STAFF RECOMMENDATION

K. Walton
NCPC File No. 6331

THE SMITHSONIAN INSTITUTION NATIONAL MUSEUM OF AFRICAN AMERICAN HISTORY AND CULTURE

October 31, 2011

South Porch

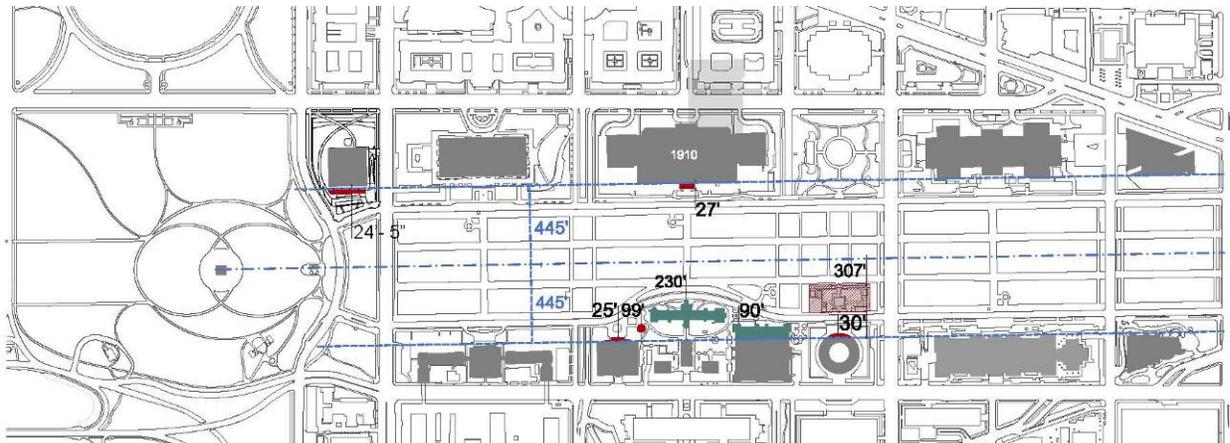
The porch is another facet of the building which has evolved since the prior submittal. While the design of the porch element still projects into the historic McMillan setback, the occupiable area has been reduced to respect the historic setback; this reduction is an acceptable solution. The remaining area of porch roof will be planted with indigenous drought resistant plants to mimic the lawn of the Mall. The overall size of the porch has been reduced close to 20% in area to 44 feet by 200 feet and the porch is now aligned with the glass base of the corona. The streamlined proportions are a marked improvement over the prior scheme.

14th Street Edge

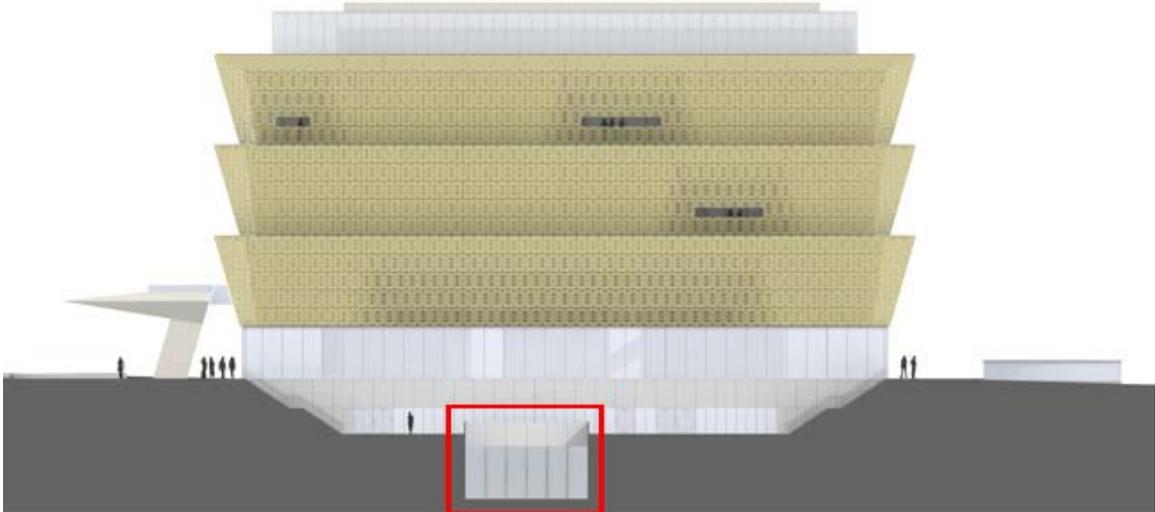
Other elements on the south and east sides of the site have been added. The food cart shelter and guard booth design require continued coordination with NCPC. The Smithsonian should also continue coordination with DDOT and the (NPS) to assure that the 14th Street and 15th Street sidewalks are reopened as soon as safety permits.

- **Refine** the food cart shelter and guard booth design in coordination with NCPC staff and other federal review agencies; and
- **Continue** coordination with the District Department of Transportation (DDOT) and the National Park Service (NPS) to assure that the 14th Street and 15th Street sidewalks are reopened to the public as soon as construction safety permits, and continue coordination on all other outstanding construction issues.
